## ADDENDUM No. 1

Reference: Spanish Fork Armory – Parking Addition  
Utah National Guard  
DFCM Project No. 08241480

**Utah National Guard  
Spanish Fork Armory  
POV Parking Lot**

**DFCM Project Number 08241480**

Refer to attached photograph top of next page for location of supplemental striping area in existing east parking area.

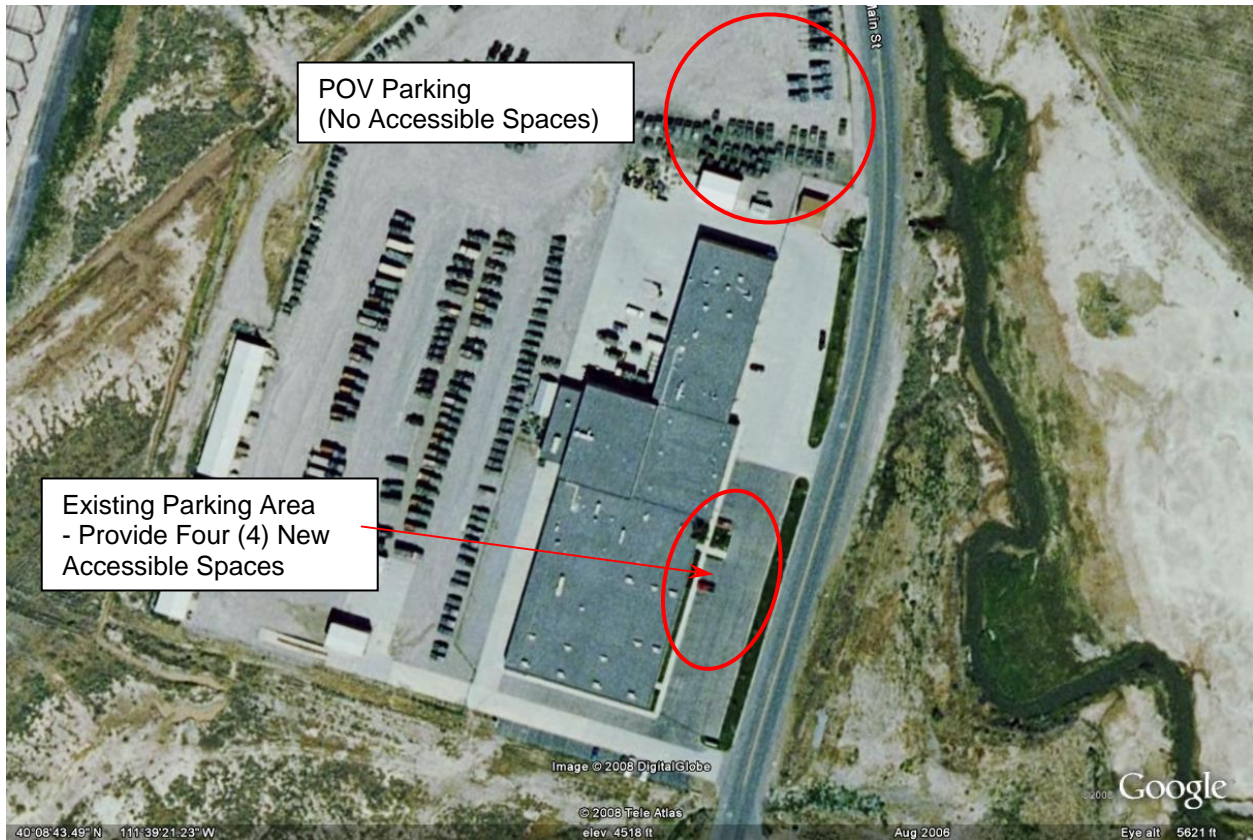
Four (4) new handicap accessible parking spaces are required as part of the overall project scope. These spaces are to be provided at the existing paved parking area east of the main Armory entrance. Two (2) accessible spaces are currently provided at this location. Contractor to provide striping for four (4) additional spaces (including one (1) van-accessible space) at the existing parking area as part of the project scope of work. Provide painted accessible space marker and standard handicap signage for four (4) new accessible spaces.

No separate payment for this item is provided. Contractor to include costs for this item under "pavement striping" unit cost item. Accessible space striping to consist of striping and handicap markings as indicated on Sheet D1 of the revised Drawings.
